# UNITED STATES PATENT AND TRADEMARK OFFICE

<b>Office Action Summary</b>	Application No. 10/789,610	Applicant(s) LIM, ROY K.	
	Examiner John Kim	Art Unit 3733

## **DETAILED ACTION**

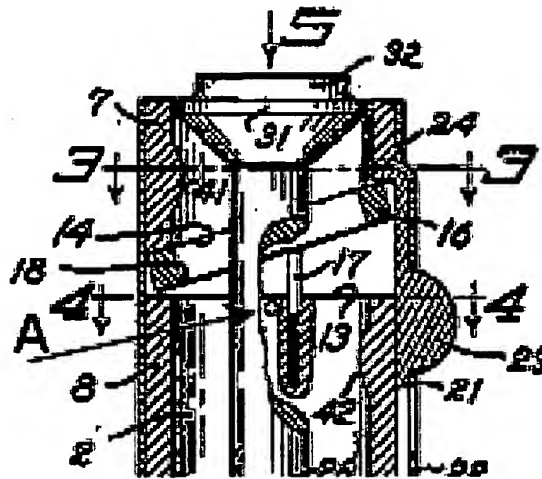
In regards to claim 1, Krafft discloses an apparatus having a base (26), a shaft (4) that is connected to the base (by 38, 34, and 28) and being slidable with respect to the shaft, a plate (18) with an aperture (which allows the fuse to enter) where the plate has two positions (figure 1 and 2) where figure 2 shows the plate in the "locked" position, one of which locks the implant in place, and a sleeve (21, 23) which partially surrounds the sleeve and is slidable with respect to the base and plate. In regards to claim 2, Krafft discloses having a ratchet mechanism (17), where the coils of the spring are the teeth of a bar and a pin (A, see figure below) is the pawl. The ratchet is connected to the base and sleeve, and is operable to move the sleeve by pushing the plate (18) which is connected to the sleeve at (24).

In regards to claim 38, Krafft has a plate (18) with two edges and an aperture, a shaft (21, 23) which is connected to the plate at one edge (near 16) and can pivot the plate around the second edge (near 18). The plate moves between two positions (figures 1 and 2) where figure 2 shows the plate in the "locked" position. In regards to claims 39 and 40, Krafft discloses having a sleeve (7), which is slidable with respect to the shaft, and the sleeve has an end portion which is able to contact a spinal rod. As discussed above and in reference to claim 41, Krafft discloses having a ratchet mechanism (17), where the coils of the spring are the teeth of a bar and a pin (A, see figure above) is the pawl.
